CITY OF LAS CRUCES

DATE: October 12, 2026

SUBJECT: Case 26VO0500067—1009 E. Court Ave

Case 26VO0500067: A request for a Certificate of Appropriateness for the construction of a metal carport located at 1009 E. Court Avenue. The subject carport, constructed to the south of the property's garage, is roughly 175 square feet; the property is zoned R-2. The property at 1009 E. Court is in the South Mesquite Overlay (SMO), however it is outside the National Register and State Register listings of the Mesquite Street-Original Townsite Historic District. An application for a retroactive permit for the carport's construction has been submitted by Teresa Renn, the property owner, who employed Lopez Welding to complete the carport.

Figure 2: Site Plan of the property at 1009 E. Court Avenue with the carport drawn in by John Castillo, planner with the City's Community Development Department.

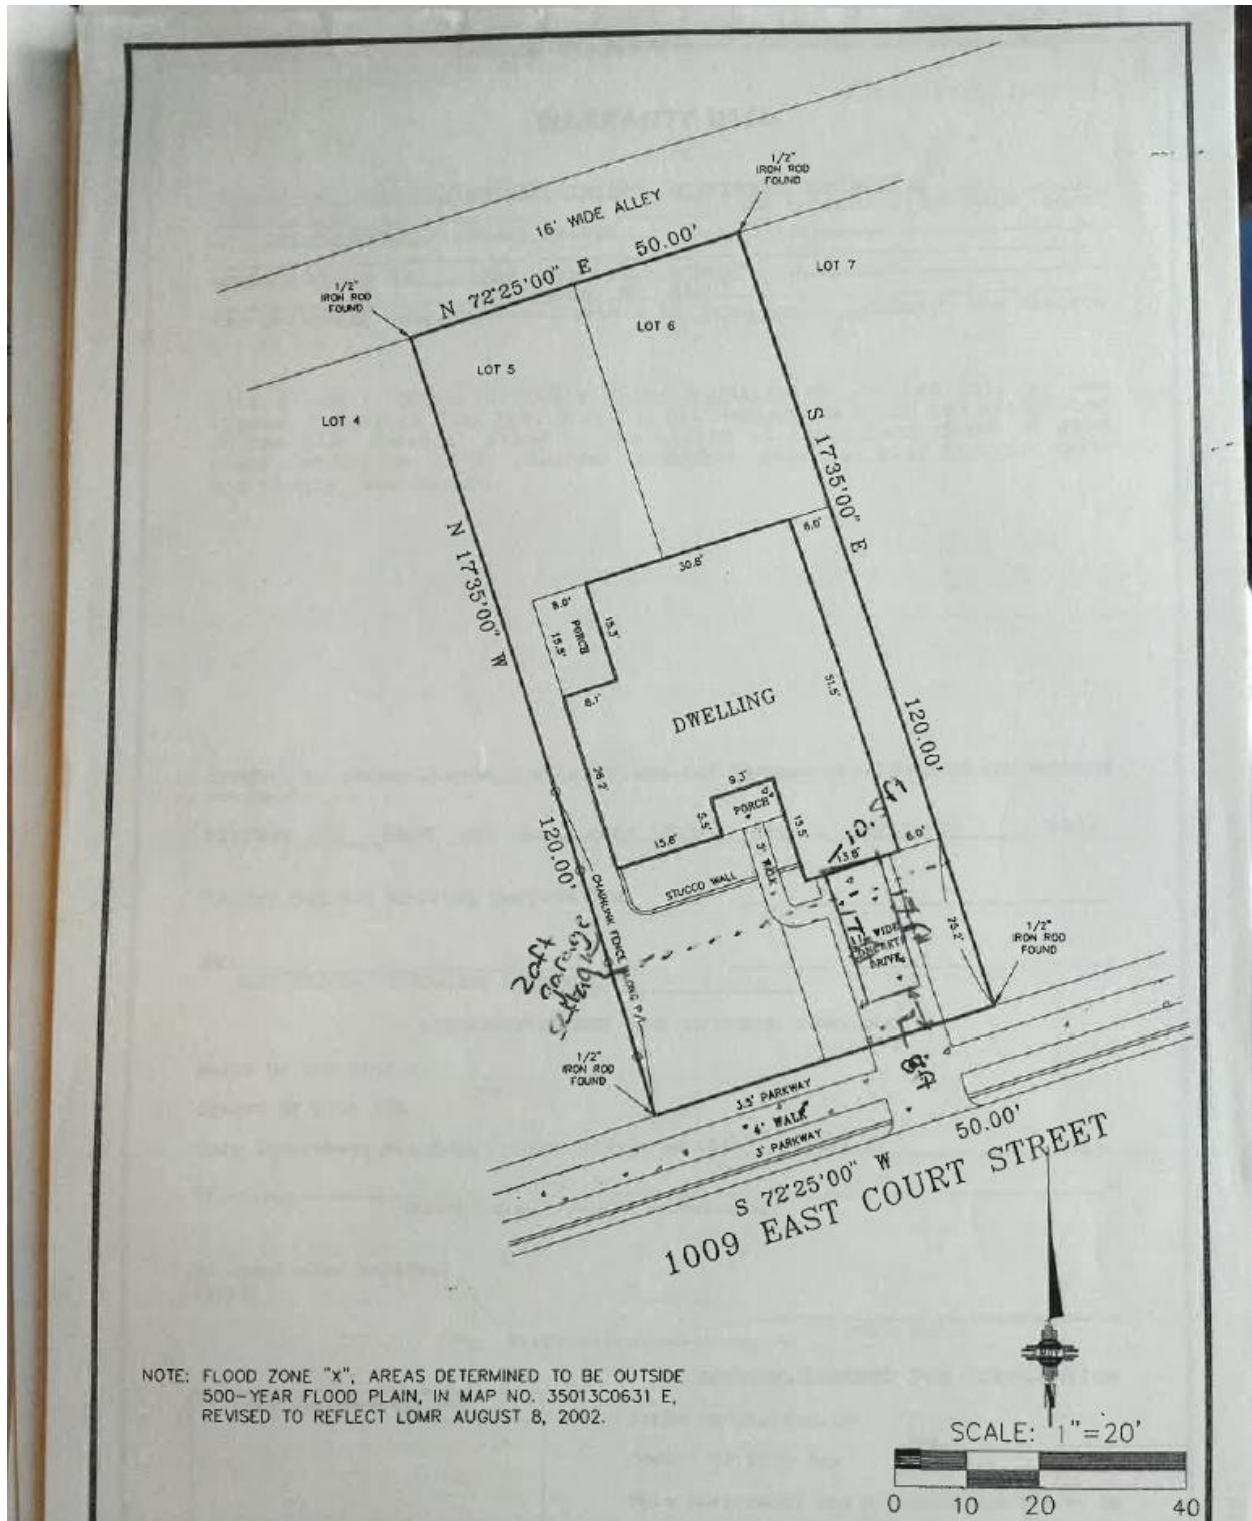
Other design considerations include the carport's placement on the lot. From the carport's position in front of the garage, it becomes a dominant part of house and the most visible part of the construction from the sidewalk and the streetway. The carport also extends past the required 20' setback in the SMO, ending within 8' of the property line; this requires a variance from the PNZ Commission if the carport is to be retained.

Following code standards, the carport as constructed does not meet the requirements of garages in the South Mesquite Overlay; as carports are not referenced in the Permitted Use Chart, garages are the nearest appropriate conforming use. Front setbacks for garages are 5’ elsewhere in Las Cruces, but garages in the SMO must be 20’ to conform to the district, as the Mesquite neighborhood was established prior to the automobile and doesn’t feature overtly automobile-influenced design in commercial or residential architecture.⁶ Design-wise, the carport is also explicitly prohibited from being constructed inside the front setback of the subject property within the SMO.⁷ The carport, therefore, when presented as a garage, does not conform to the setback requirements of a garage. It also does not conform to the code requirements of an addition to an existing building, which requires that additions be subject to the original construction and must be setback from the street-facing façade.⁸

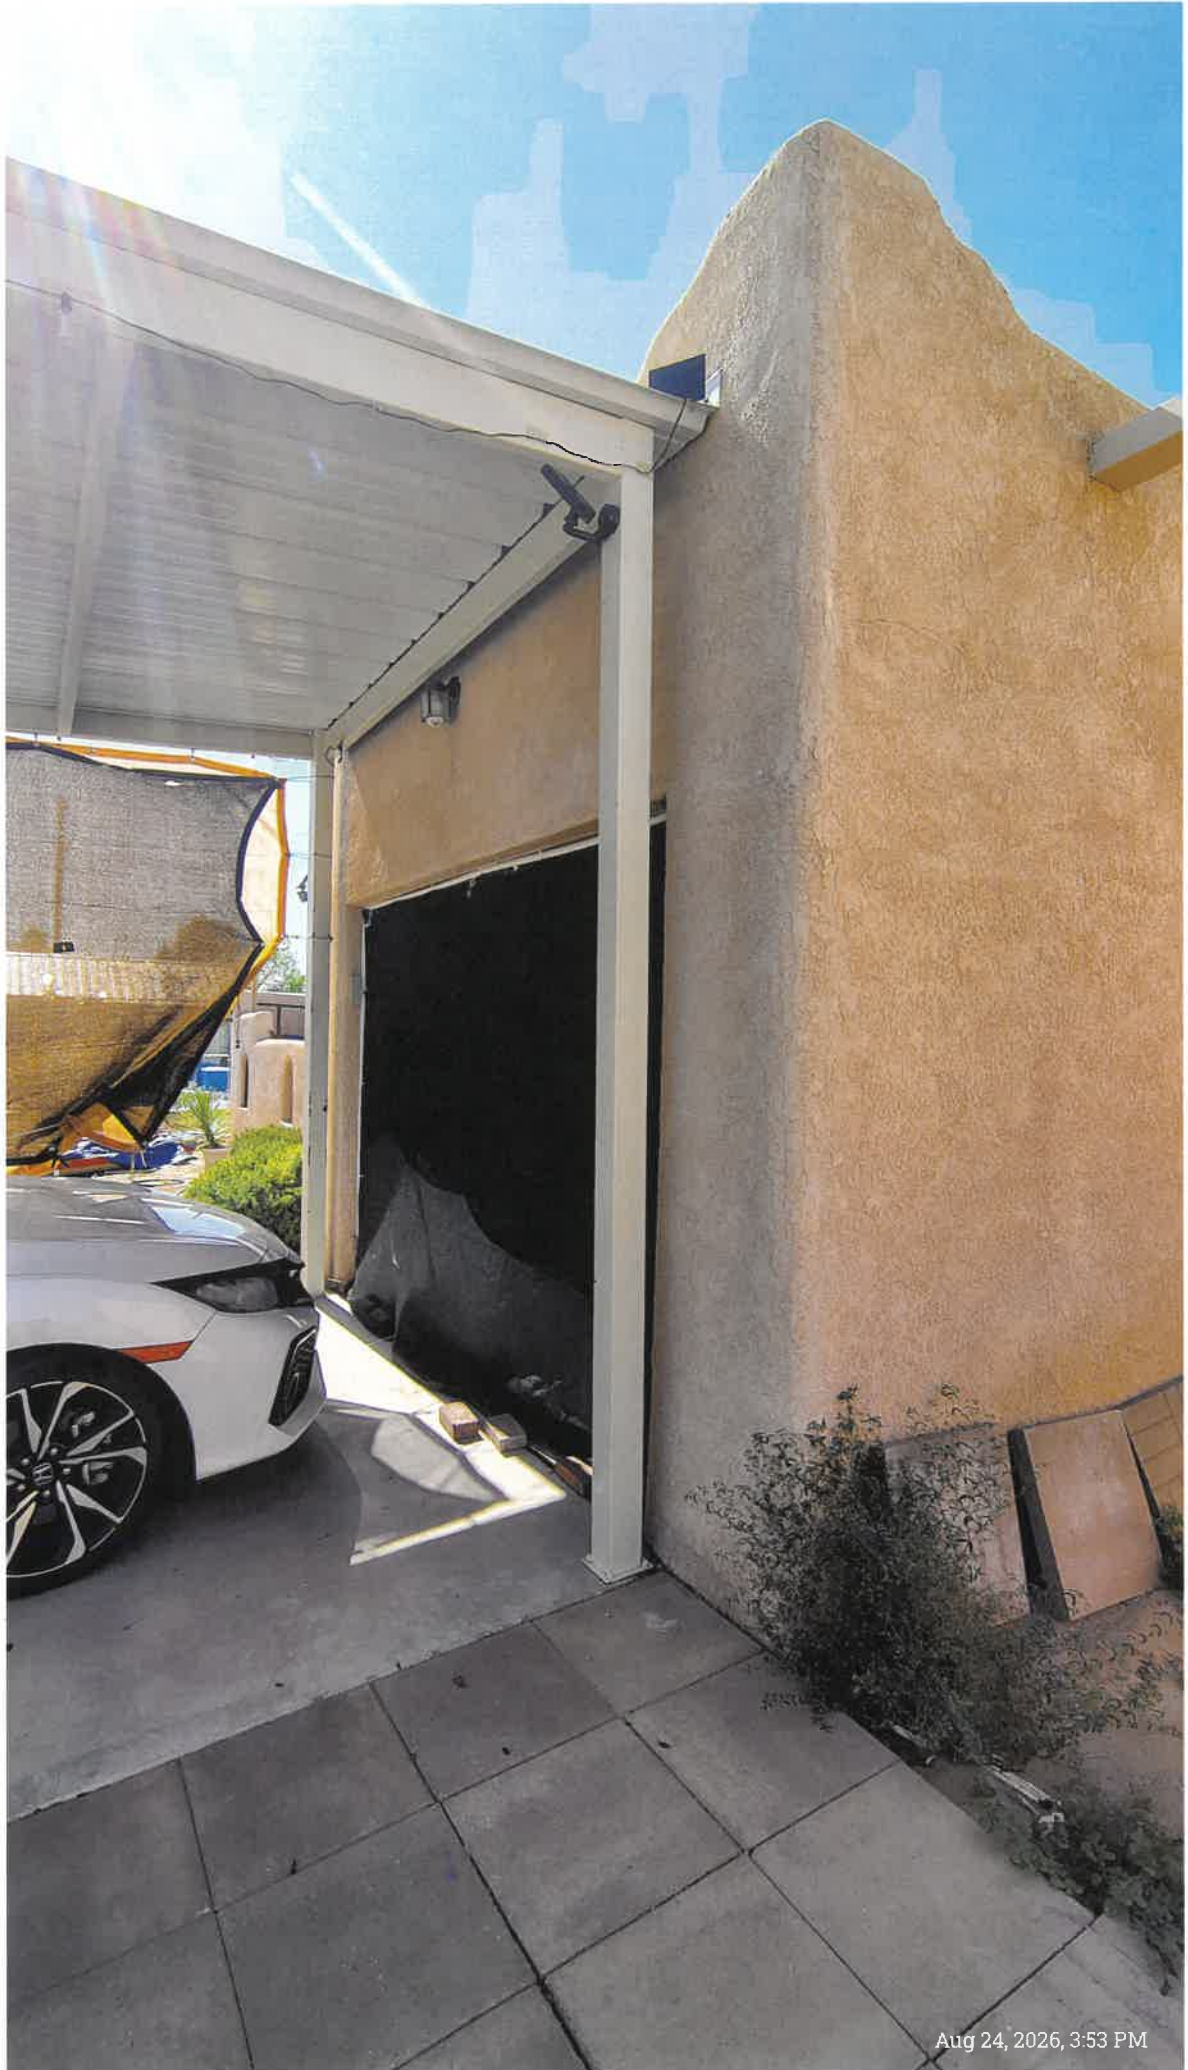
The carport consists of four metal posts, supporting a simple roof frame covered with a sheet of standing seam. Contractor notes describe construction as four 4"x4" square tubing for posts; seven 6" purlins for the roof construction; and 26 gauge sheet R panel metal for the roof. Visually, it is a white metal carport that extends from the garage of the residence at 1009 E. Court. The carport is roughly 175 square feet in plan and is directly attached to the residence; it is approximately 10' in height, placing it just under the parapet of the house.

1. The carport was constructed using pre-formed metal materials that are powder-coated white. These exact materials were not historically present in the Mesquite Street Historic District. The neighborhood has established via City Ordinance that this carport is not their preferred interpretation for modern construction, however, it may be excused, allowed, and limited to this instance. While the design of the carport maintains a compatible roofline and massing with the residence and is not out of scale with the surrounding streetscape, it also blocks views from the street of the building and—most particular for the South Mesquite neighborhood—the parapet of the front facade.

- a. Staff recommends that HPC require the property owner to either stucco the carport posts and paint them to match the house or else paint the carport brown to lessen the stark visuals created by the white metal and create a facsimile of wood, which is more in keeping with the materials of the neighborhood; while the color white was present in and around the neighborhood historically, it was generally reserved for lime plaster or wash applications—historical examples of metal were not painted or powder-coated. Staff also recommends, should the property owner need to replace the standing seam metal roofing material as has been intimated due to an issue with installation, that she use a corrugated or standing seam metal that is either unpainted coreten or weathered metal; these changes will accommodate design requirements.
